SUBJECT/OBJET: **CRIME PREVENTION THROUGH ENVIRONMENTAL DESIGN**

REFERENCE: Lincoln Fields Transit Station

Audit Performed: November 10, 1999

Lincoln Fields Transit Station (Audit performed November 10, 1999)

Interior of the Main Platform

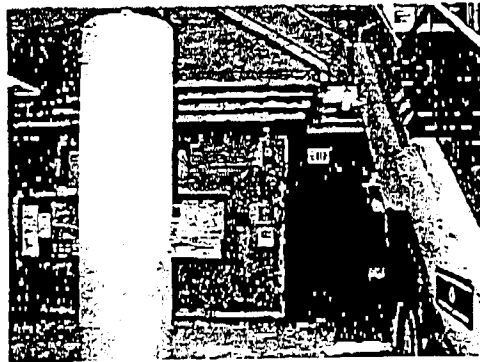
The signs used to indicate the emergency call boxes are small and cannot be identified unless you are near them. I would suggest these signs be changed to show a red undertoned picture of a phone since red is usually associated to an emergency.

This picture was taken from approximately 10 yards away. I had to be within a few yards to recognize that the yellow and black sign on the wall had a downward arrow indicating an emergency call box.

<u>Item</u>	<u>Status</u>	<u>Completion Date</u>
Signage	• Regional Police to provide CPTED recommendations re signage	January 2000
	• Review and update of all station signage by Public Info	March/April 2000
Surveillance	• Pay phones and Teledon to be relocated to more visible area. (Public Info/Plant)	February 2000

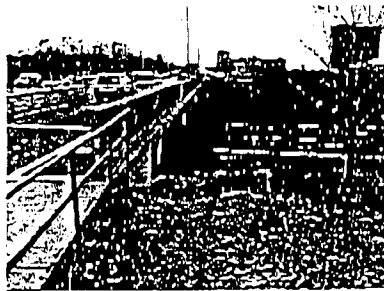
The security safety features built into the ticket office are advantageous to the employees. There are mirrors, talk boxes and surveillance cameras. There are not many suggestions I can make with respect to this area. The only suggestion I can provide is to increase the surveillance from the office. The employee has the ability to survey the inside of the main platform but

cannot see directly outside toward the doors leading to platforms 1 & 2. I would suggest that windows be installed in the north wall of the office allowing surveillance from inside and out.

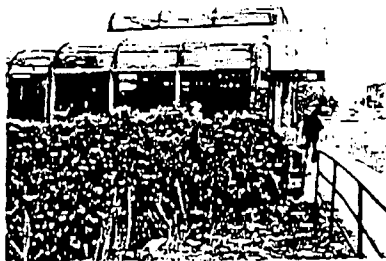
The emergency call boxes were located at each end of the platforms. There is a considerable distance between them and thought may be given to additional call boxes.

Consideration may be given to increasing the number of convex mirrors in the stairwells leading to the platforms in order that the presence and identity of others can be detected around corners.

• Installation of Emergency call boxes by Plant on East and West platforms	May 2000
	• Install additional convex mirrors (review by security to identify locations)	February 2000
Outside Surveillance	• Tinted glass to be replaced by clear glass as need arises (Region)	To be reviewed with Region
